PCN# : P463A
Issue Date : Aug. 07, 2014

Information Only Notification

No 2D barcode and sequence number on BOXTNR(BOX TAPE AND REEL) label.

BOXTNR(BOX TAPE AND REEL) Label Content:

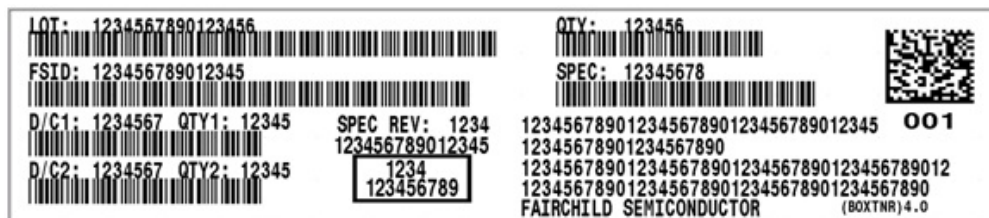
Description of Change (From) :

- 2D barcode will be added in inner box label (BOXTNR:BOX TAPE AND REEL).
- 2D barcode will contain LOT Number, Inner Box Quantity and Sequence ,For example: X000005982 +05000 +001.
- Number sequence will be specified below the 2D barcode
- Maximum size of 2D barcode is 11mm*11mm
- 2D barcode on inner box label is optional.
